ADDENDUM NUMBER I

DATE: February 9, 2026

PROJECT: Newark Valley Central School District 2023
Capital Project – Phase III
High School Air Conditioning

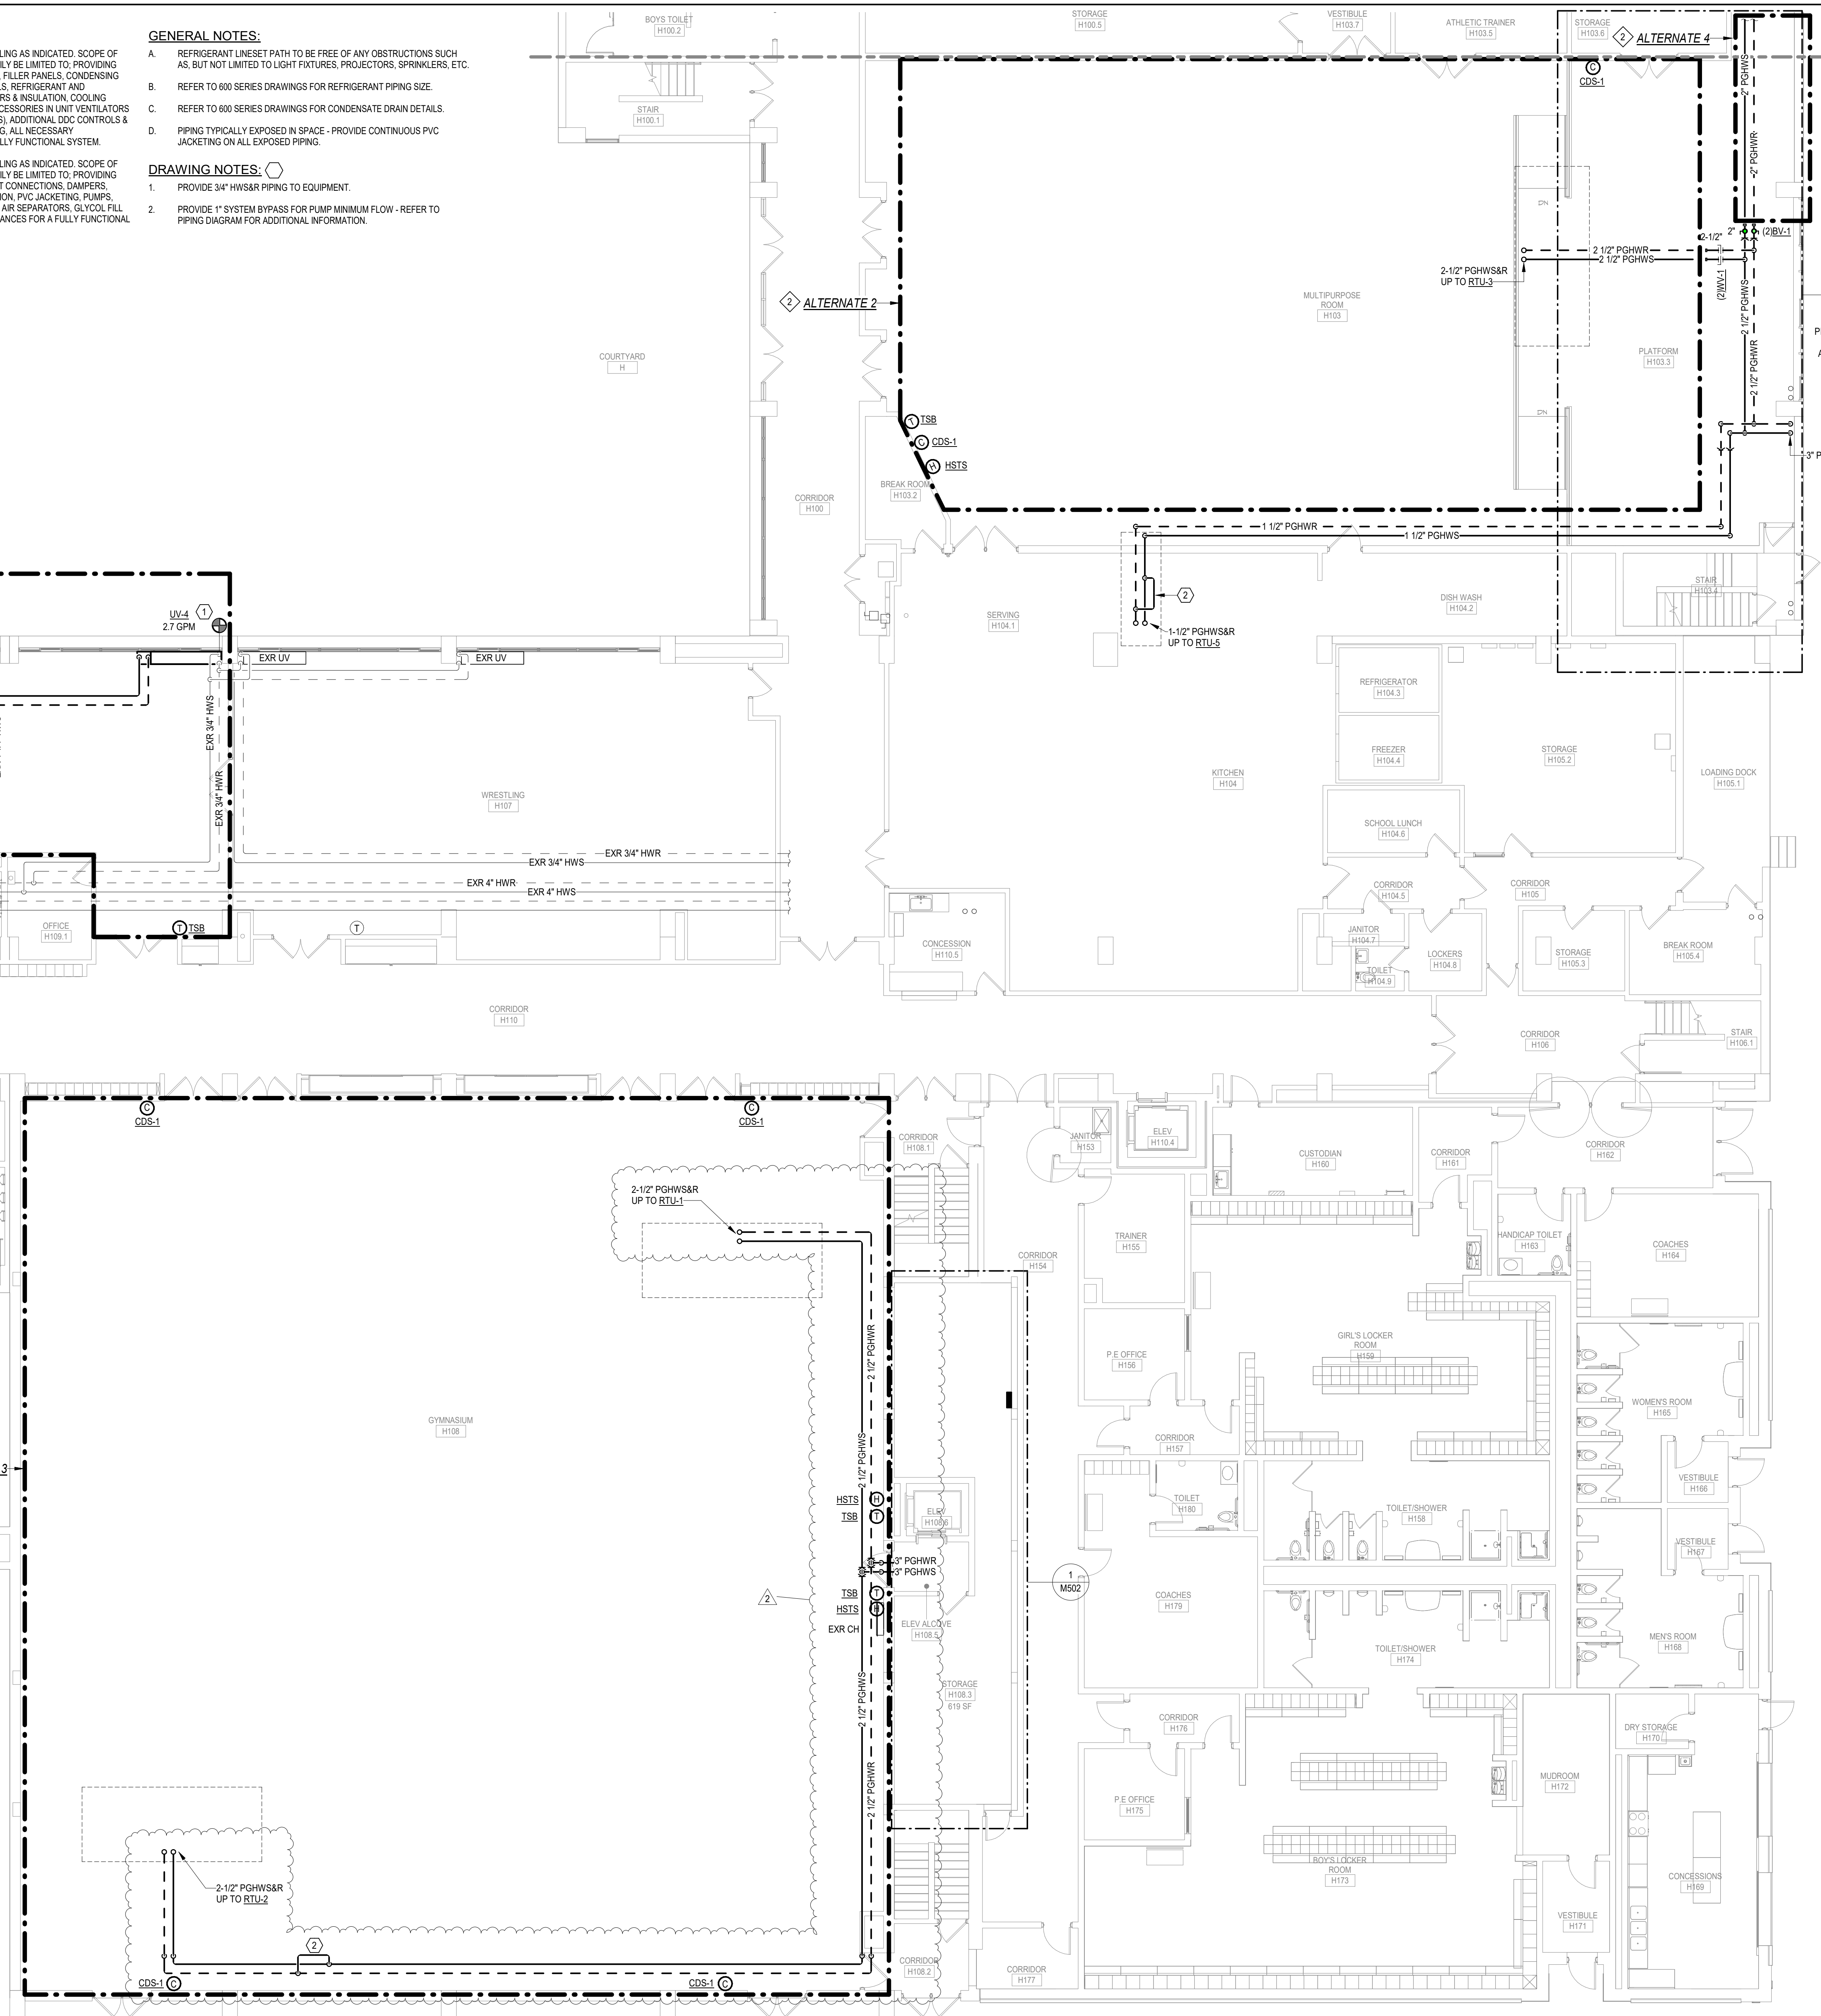
- a. REVISE as shown on the attached drawing M309-ADI.
22. M401 - FIRST FLOOR PIPING PLAN - AREA 1
 - a. REVISE as shown on the attached drawing M401-ADI.

1 SECOND FLOOR PIPING PLAN - AREA 1
M404-AD1 1/8" = 1'-0"

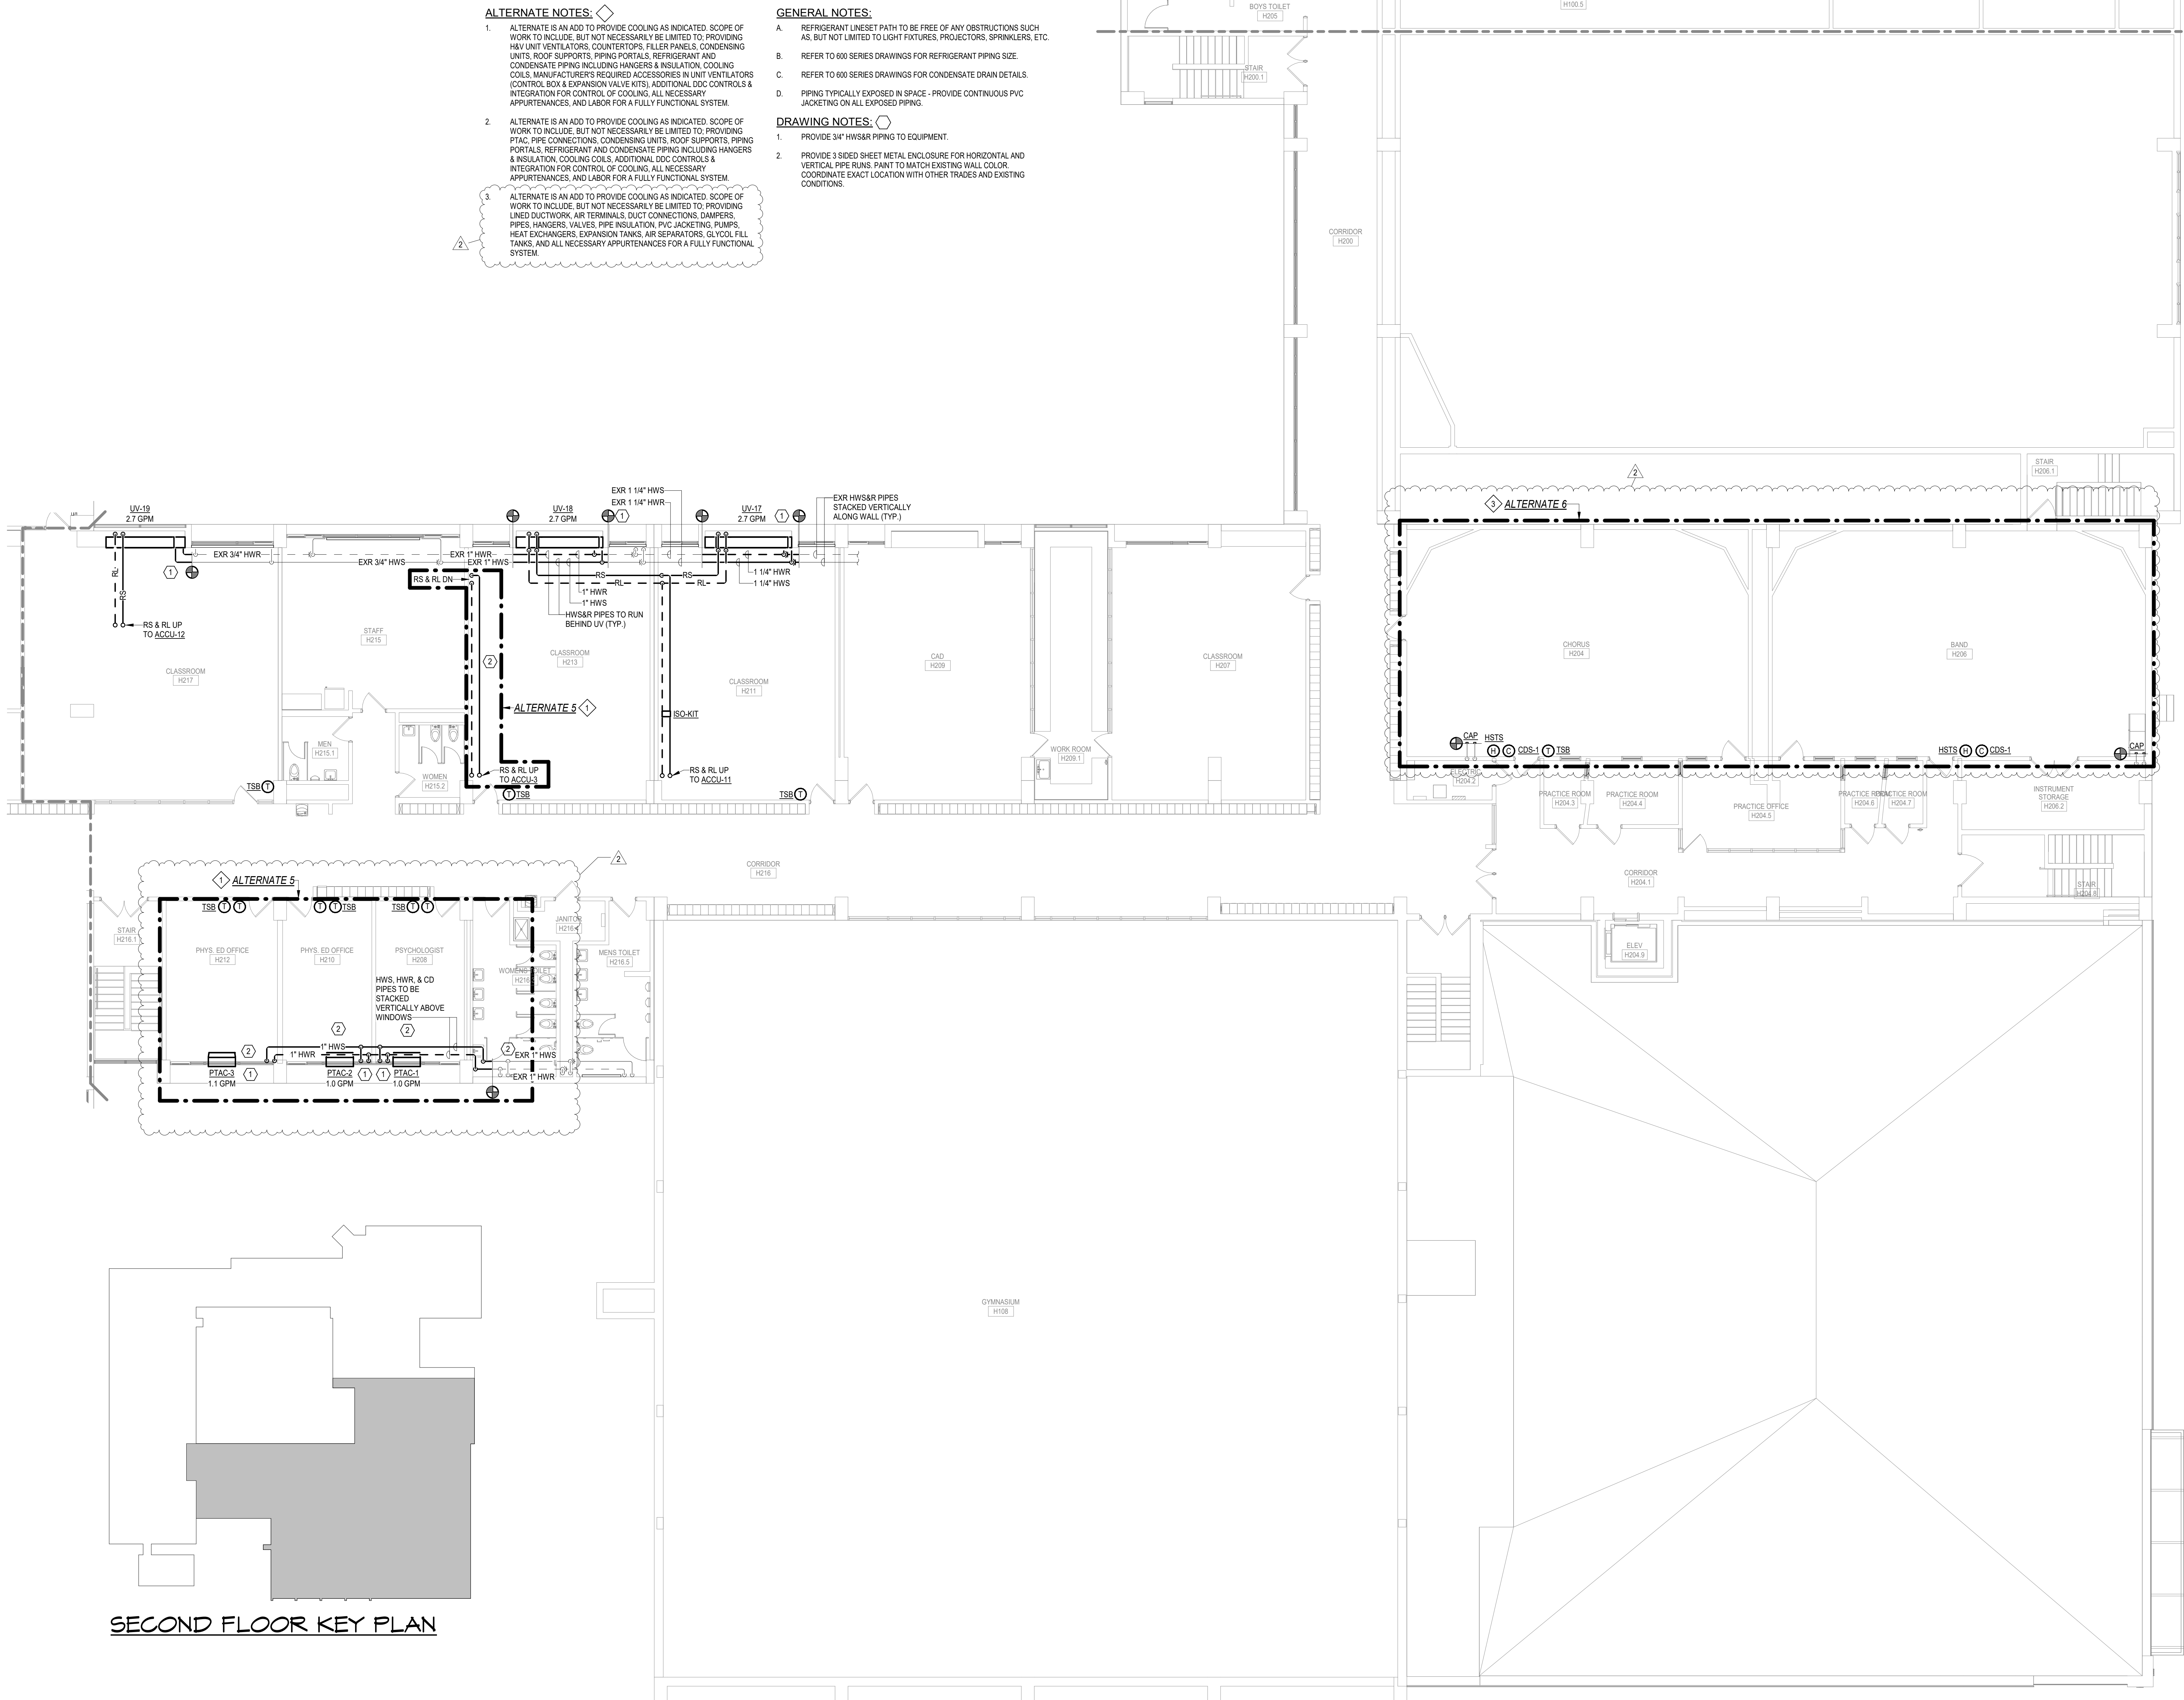
23. M404 - SECOND FLOOR PIPING PLAN - AREA 1
 - a. REVISE as shown on the attached drawing M404-ADI.
24. M407 - FIRST FLOOR CONDENSATE PIPING PLAN
 - a. ADD the attached drawing M407-ADI.

1 ENLARGED PIPING PLAN - BASEMENT MECHANICAL ROOM
M501-AD1 1/4" = 1'-0"

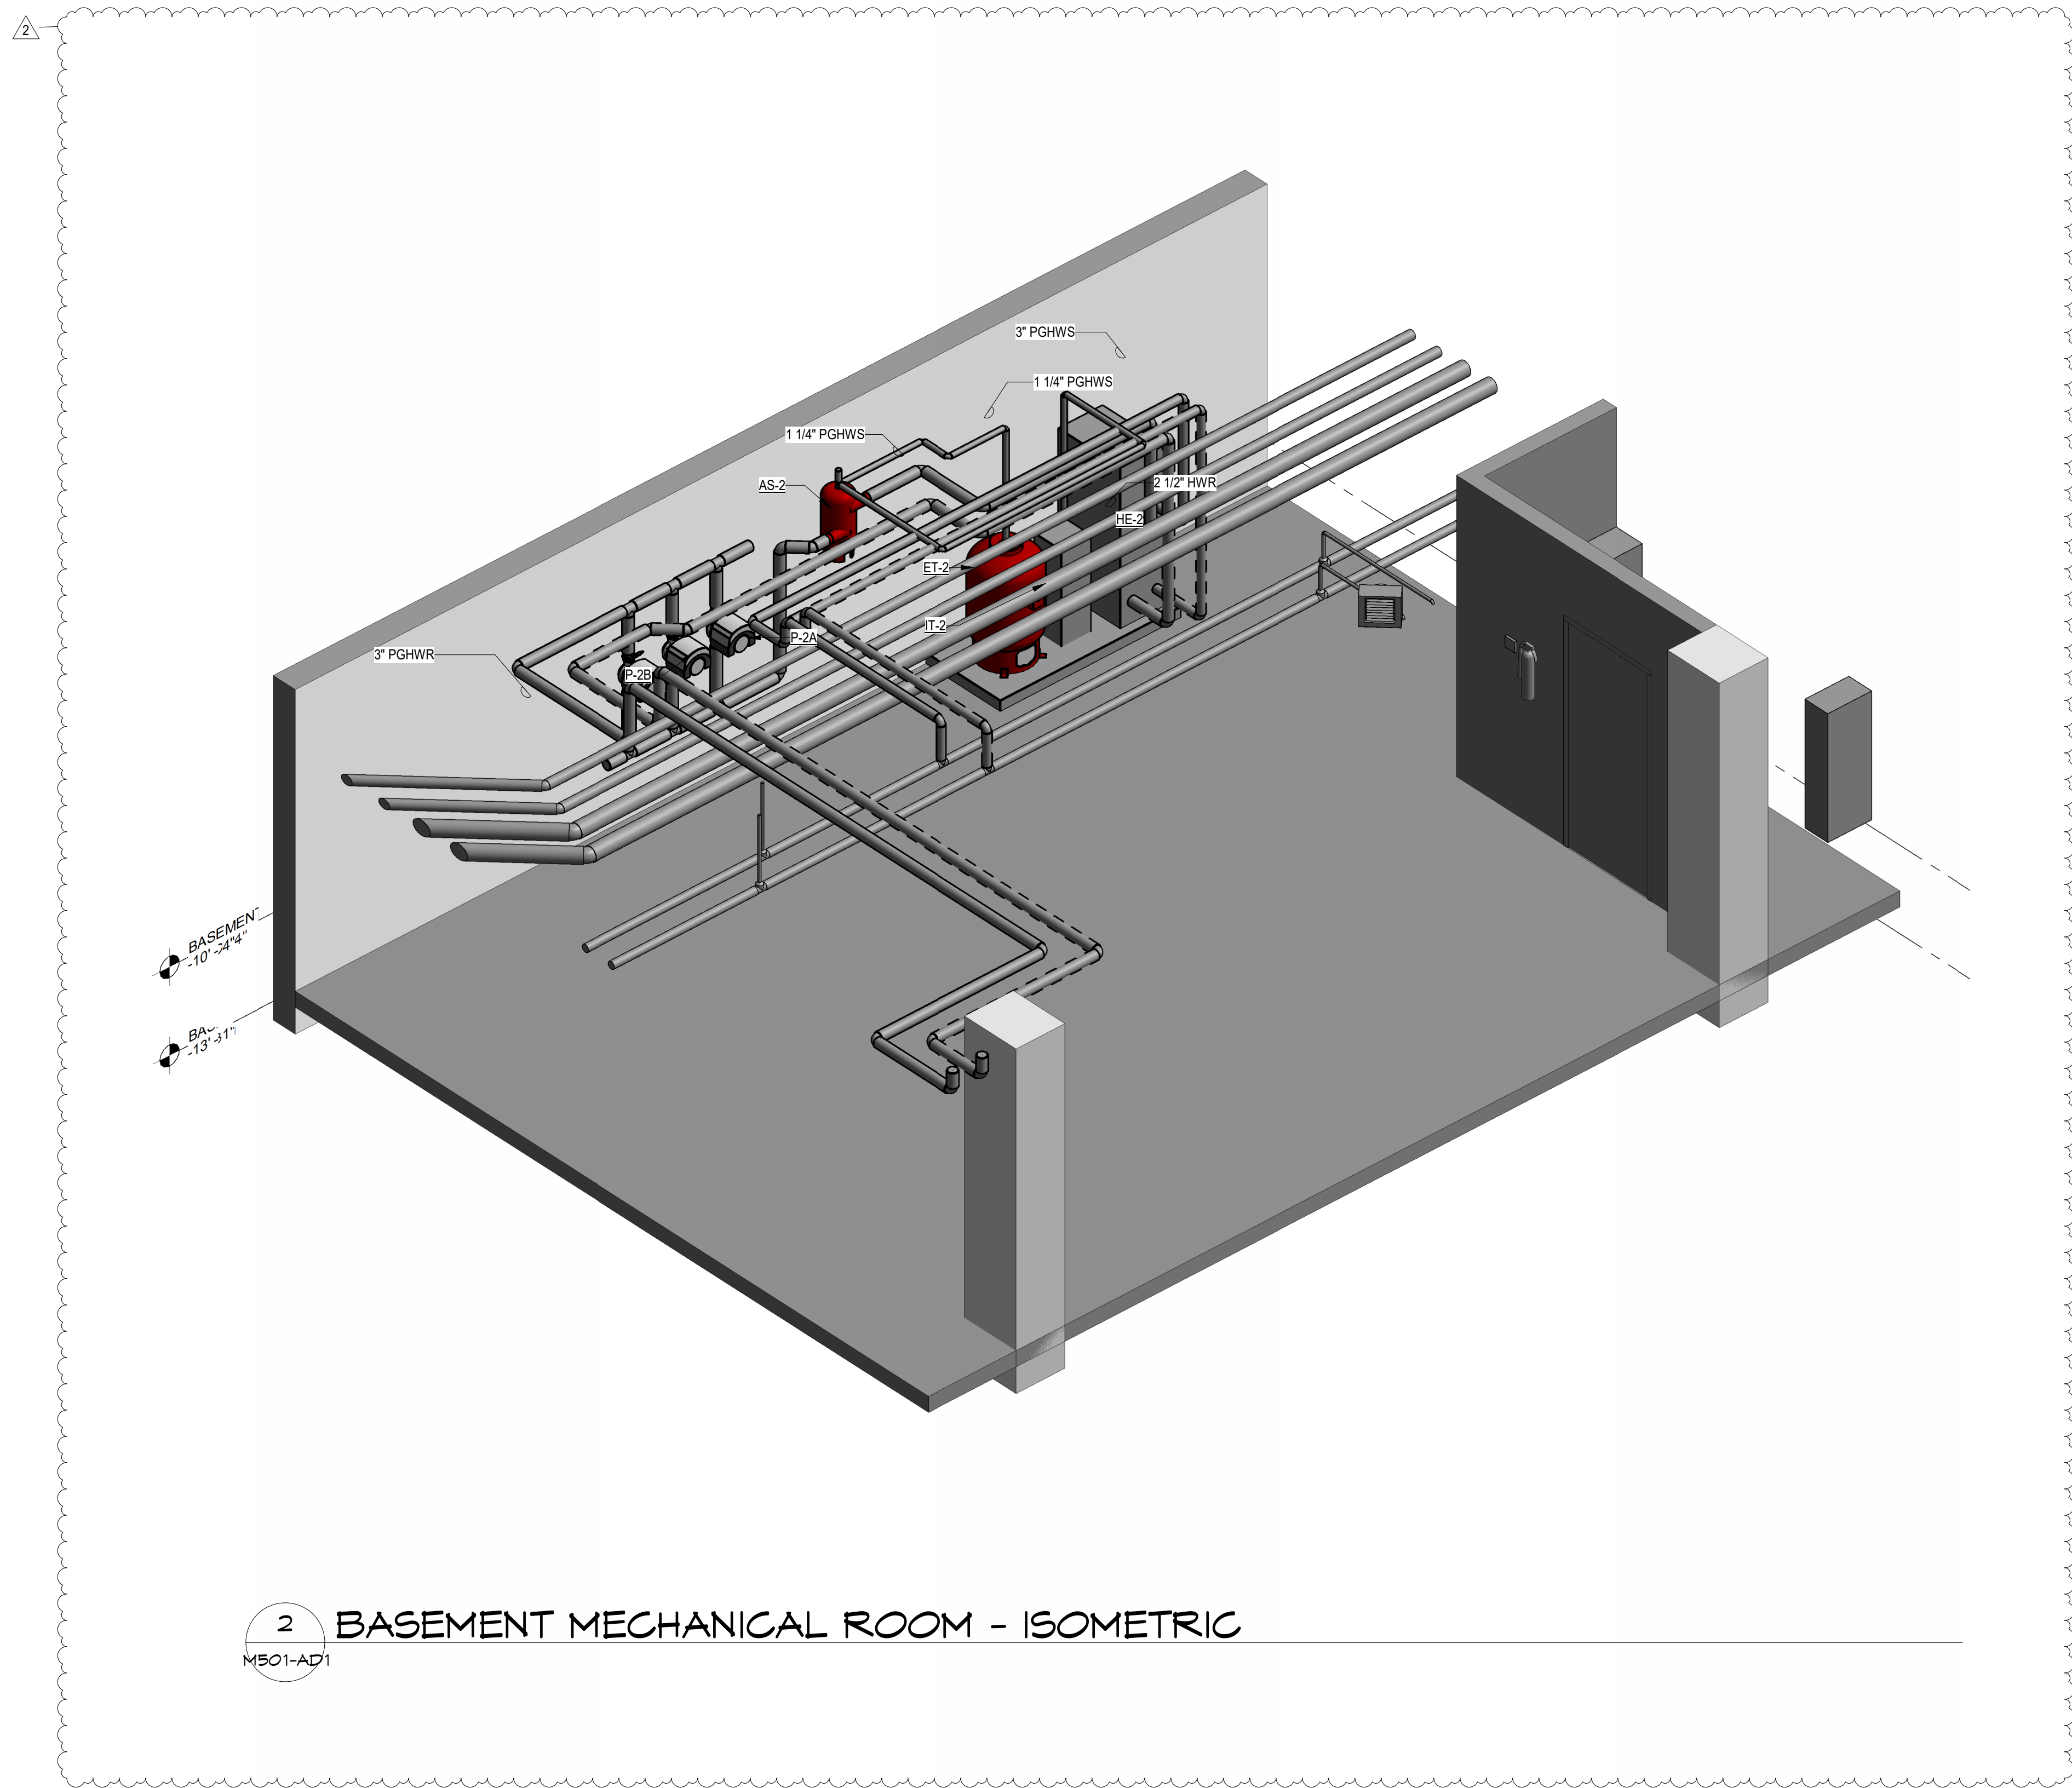
25. M408 - SECOND FLOOR CONDENSATE PIPING PLAN
 - a. ADD the attached drawing M408-ADI.
26. M501 - ENLARGED PLANS - BASEMENT MECHANICAL ROOM
 - a. REVISE as shown on the attached drawing M501-ADI.
